TELEPRINTER ANCILLARY WORKING AT TG(L)1032
 OUT OFFICES.
 ALARM AND ANSWER-BACK ARRANGEMENTS.

C
		27-535	
		27391	B

FIG.1 CONNEXIONS FOR
 EXTENSION BELL
 OR BUZZER.

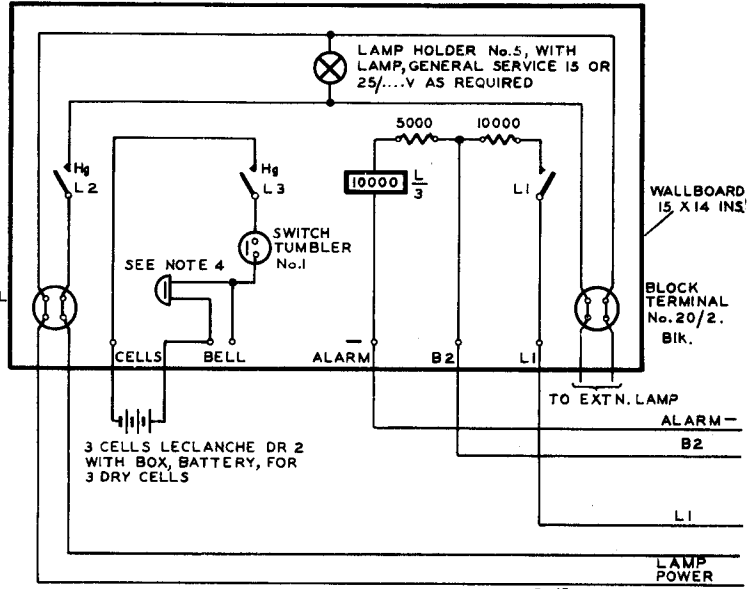
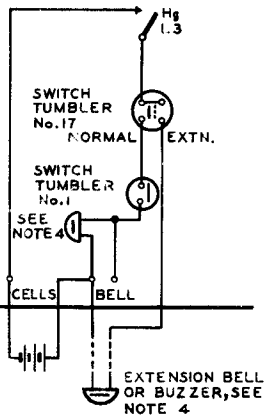
REDRAWN FIG.1 ADDED.
 SWITCH TUMBLER No.17 AND
 EXTENSION BELL ADDED.
 Amendment.
